## SERVICE INSTRUCTION

**Number:** 113-2084

### Changes to Saab Original Service Programmes

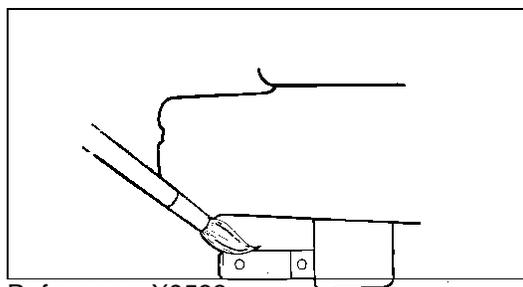
When fitting the towbar attachment, there is a danger of it not locking correctly to the coupling pin if the pin is dirty or inadequately greased.

Clean the coupling pin as necessary. Grease the coupling pin at every service interval with Molycote 33. Check that the towball unit is easy to fit and remove and that it locks securely.
